V2500-A5 PROPULSION SYSTEMS SERVICE BULLETIN

This document transmits Revision 3 to Service Bulletin EV2500-72-0399

V2500-ENG-72-0399
Transmittal - Page 1 of 2

ENGINE – PROVIDE A NEW 2ND STAGE TURBINE ROTOR BLADE RETENTION CONFIGURATION

Location of the stage 2 turbine blade lock retainers
Fig 1

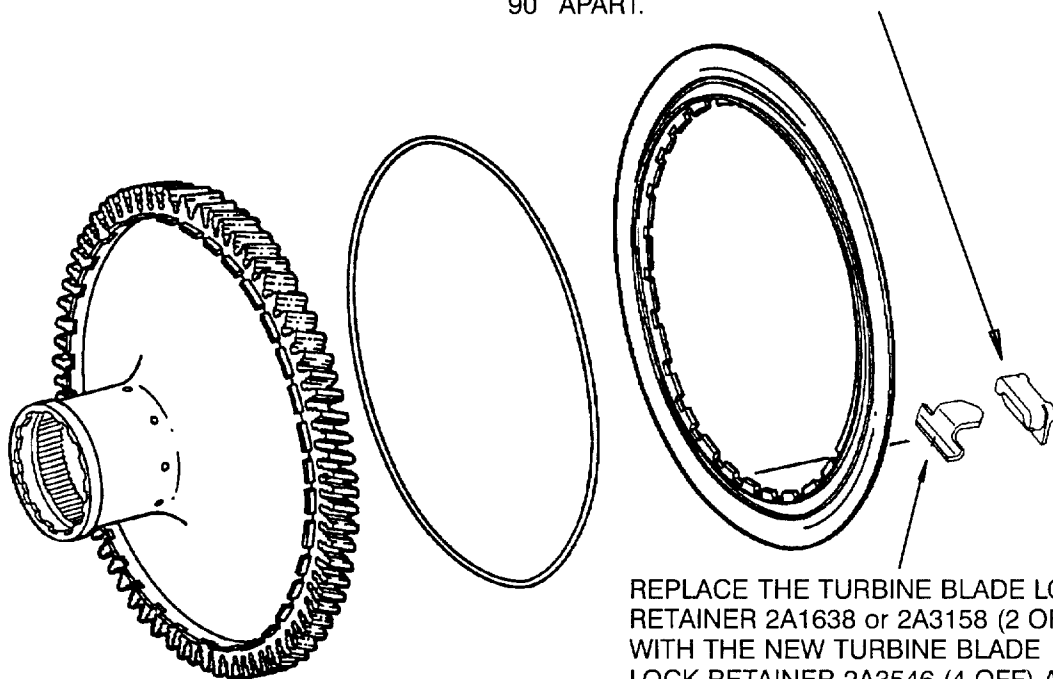
REPLACE THE HPT LOCK 2A1097 (2 OFF) WITH THE NEW TURBINE BLADE LOCK RETAINER 2A3545 (4 OFF) AT FOUR SLOT LOCATIONS 90° APART.

REPLACE THE TURBINE BLADE LOCK RETAINER 2A1638 or 2A3158 (2 OFF) WITH THE NEW TURBINE BLADE LOCK RETAINER 2A3546 (4 OFF) AT FOUR SLOT LOCATIONS 90° APART.

- (a) Select 4 slot locations 90 degrees apart for Retainer/Lock installation. (See Figure 1).
 - (b) Install 2nd Stage High Pressure Blade Lock Retainers, P/N 2A3546 four (4) off and Turbine Blade Locks, P/N 2A3545 four (4) off.

Lock/retainer assembly
Fig 2

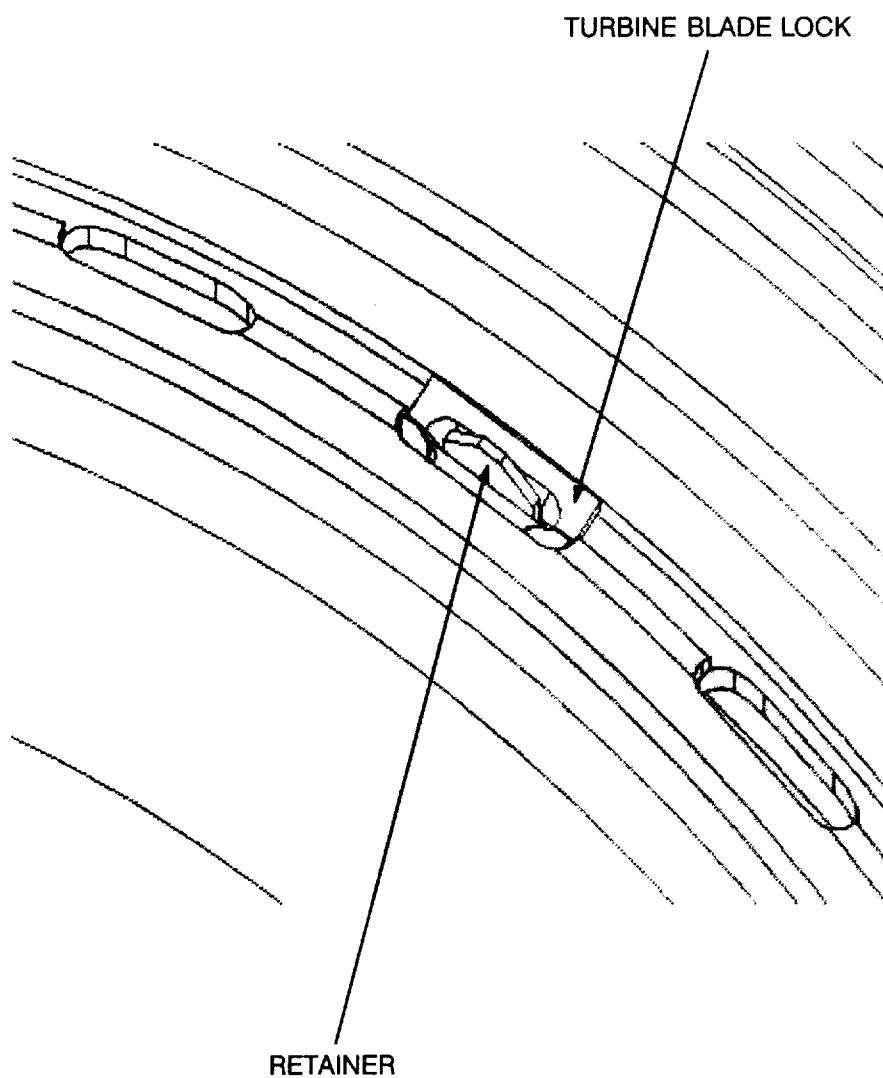
- (i) Place Retainer P/N 2A3546 in one of the selected slots wing first, with the wing on the OD side of the slot (See Figure 2).
 - (ii) While holding the Retainer's position against the front surface, slide Lock PN 2A3545 into slot and guide the Retainer tab into the center of the lock.

Fixture alignment
Fig 3 sheet 1

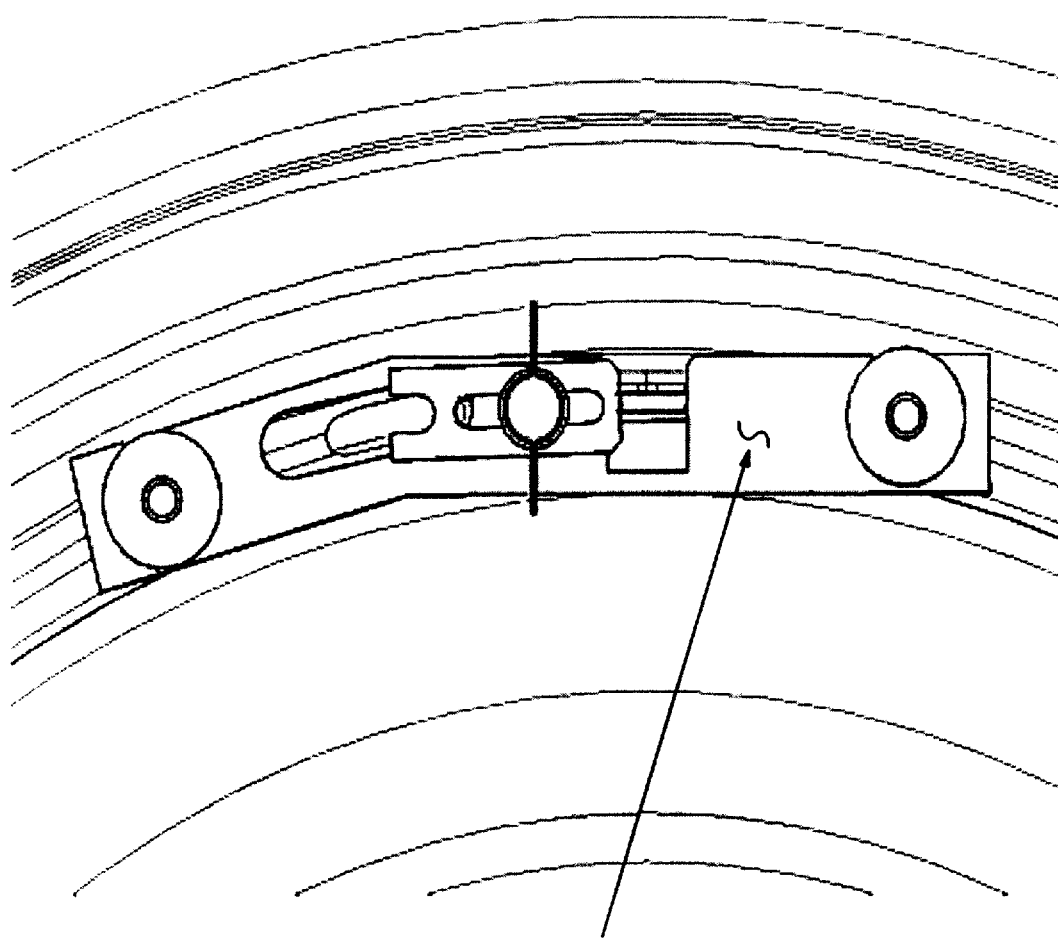
- (iii) Push the lock flush to the surface of the disk.
 - (c) Install Hold/Bend Fixture, P/N IAE 1P16479.
 - (i) Orient the top plate with the cutout facing away from the engine centerline as shown in Figure 3, Sheet 1.

Fixture alignment
Fig 3 sheet 2

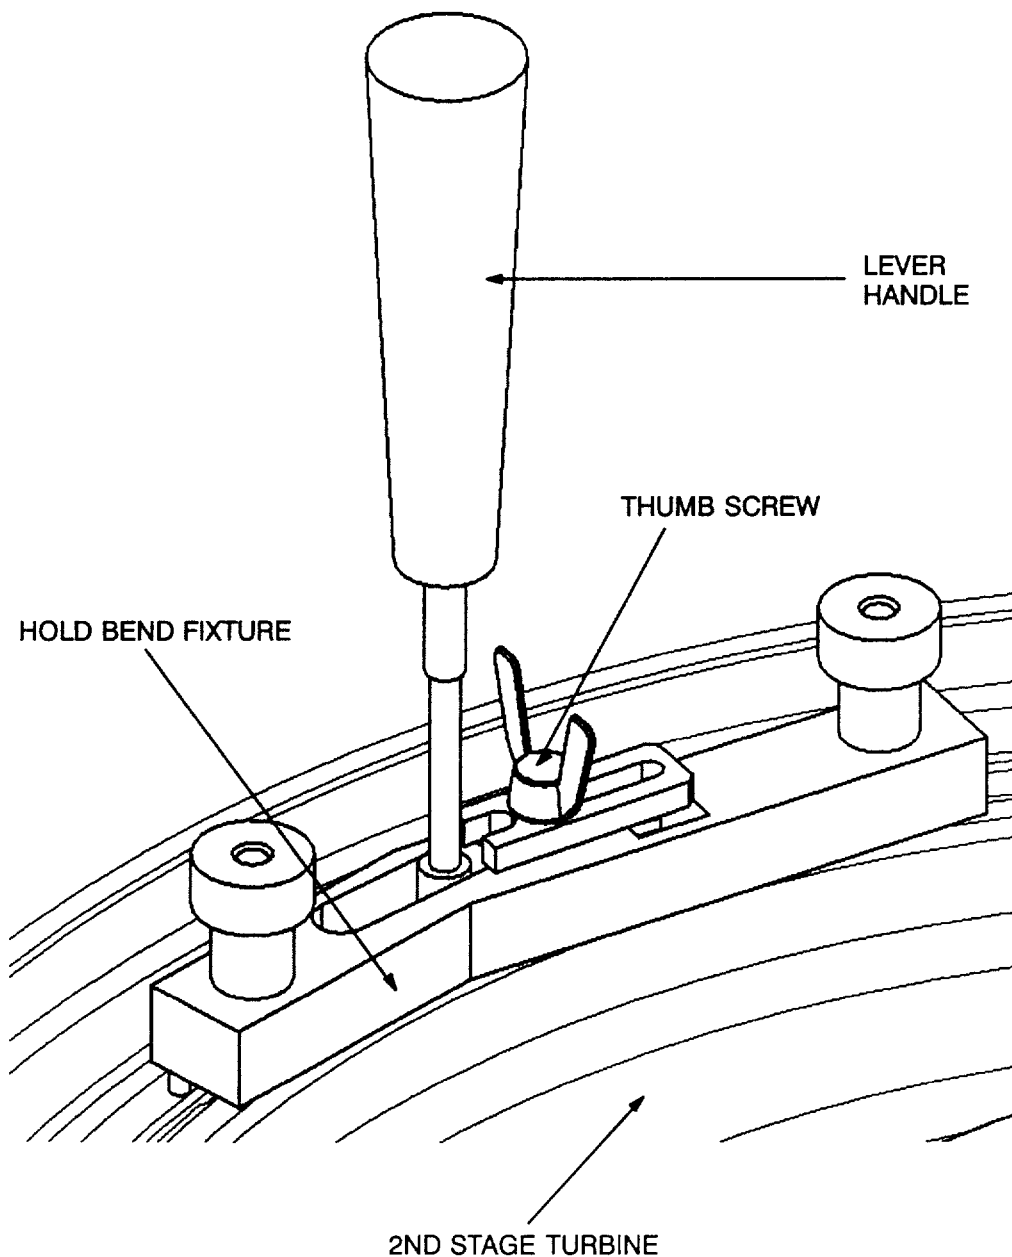
NOTE: IF THE LEGS DO NOT ENGAGE THE SIDE PLATE WHILE TIGHTENING, INCREASE THE EFFECTIVE LEG LENGTH BY TURNING THE KNOBS ONE OR TWO TURNS TO THE LEFT AND THEN TRY AGAIN.
 - (iv) When the top plate is properly secured, insert the lever arm into the slot by holding the lever arm parallel to the hub and turning the end into the slot counterclockwise. Once in the slot, slide lever arm to the left and straighten to the upright position, perpendicular to the hub as shown in Figure 3, Sheet 2.

Bending retainer
Fig 4

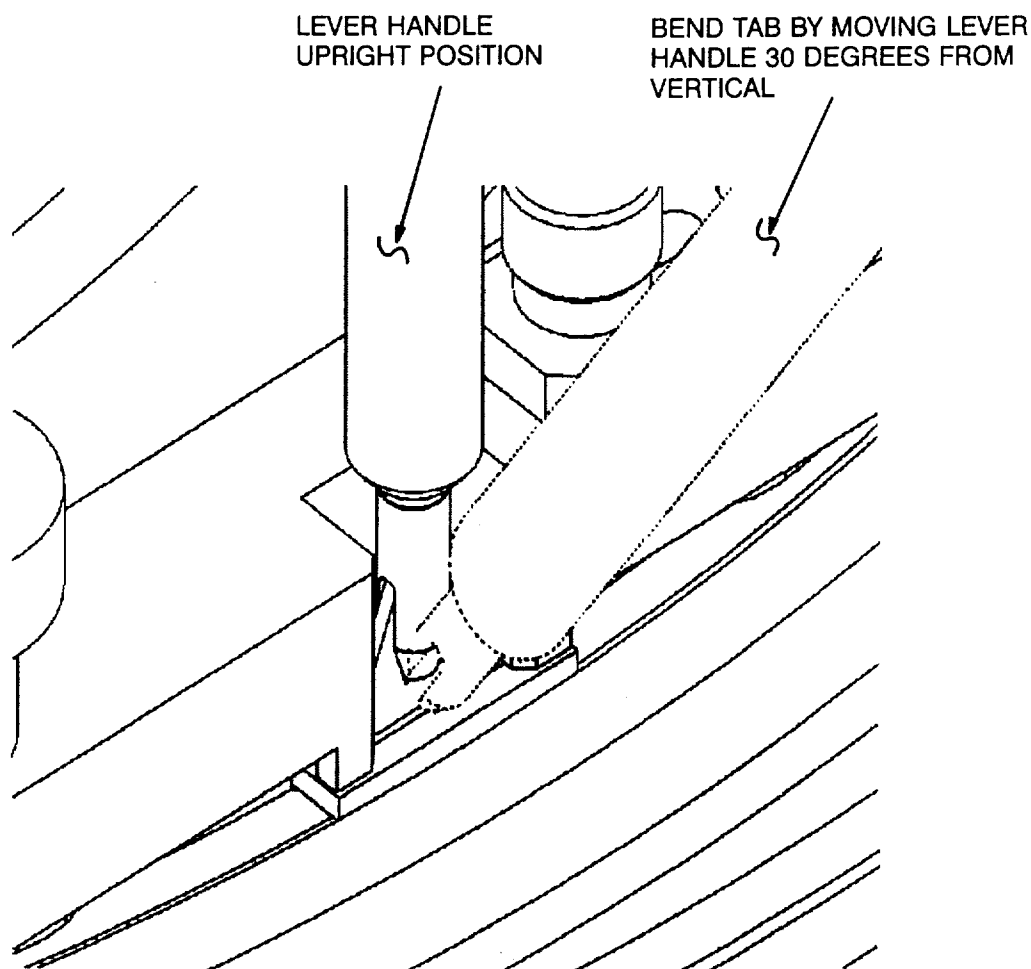
- (i) Center the slot of the bender on the Retainer's protruding tab as shown in Figure 4. Bend the Retainer away from the engine centerline 30 degrees to initiate the bend.
- (ii) Use the angled end of the drift with a mallet to bend the tab three-quarters of the way to the surface of the HPT Retaining Plate as shown in Figure 4.
- (iii) Flip the drift over and use the flat end to finish bending the Retainer to be sure it is perpendicular to the HPT Retaining Plate as shown in Figure 5.

2nd stage turbine blade lock
Fig 5 sheet 2

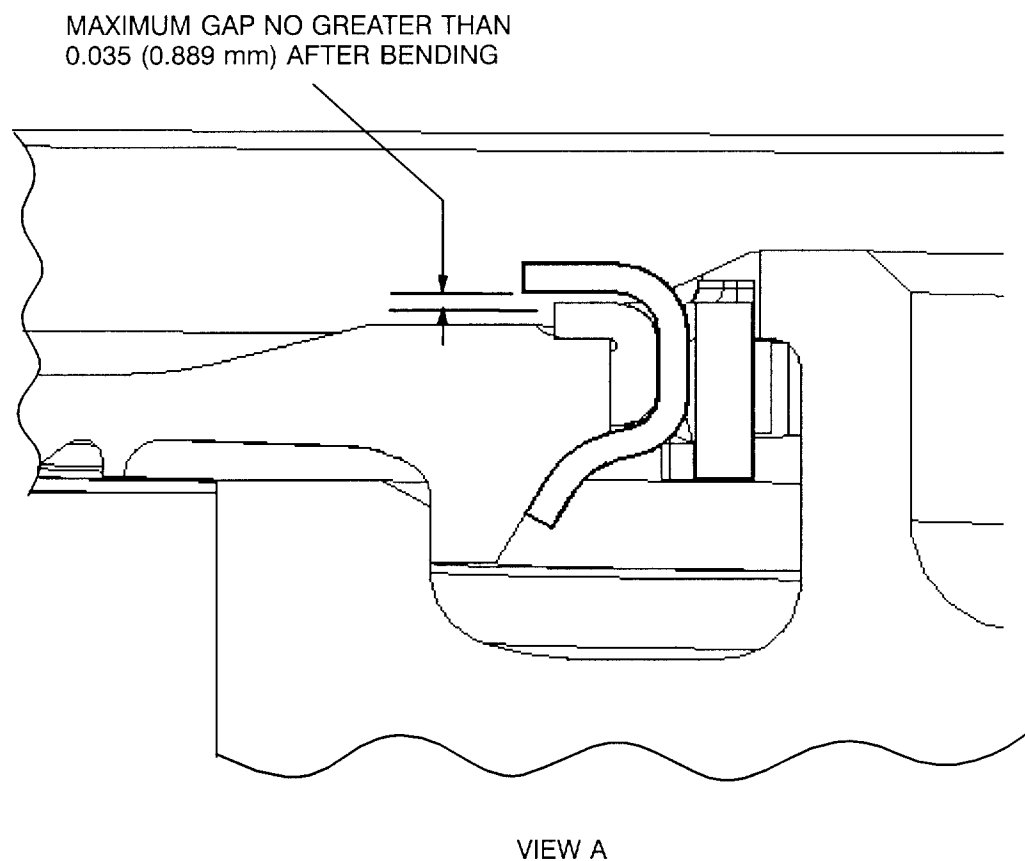
- (i) Tab must be parallel to disk surface as shown in Figure 5, Sheet 2.
- (ii) Measure the gap between the top of the lock and the inside surface of the Retainer tab. Requirement: Gap must be no greater than 0.035 (0.889 mm) as shown in Figure 5, Sheet 2.

- (iii) If the bend does not meet the requirement, remove the Retainer and discard it, repeat process with new Retainer. Do not try to fix the Retainer by unbending and repeating the process.
- (g) Repeat procedure for the remaining selected slots until all 4 locations are properly installed.
- (h) Identify the 2nd stage rotor and stator assembly, PN 2A2422, 2A2522, 2A2822, 2A2622 as PN 2A4032, 2A2522-001, 2A2822-001, 2A4232 respectively by the approved procedure in Reference 9, Chapter/Section 70-09-00 Marking of Parts. Marks the new identification adjacent to the old identification. Use the vibration peen method.
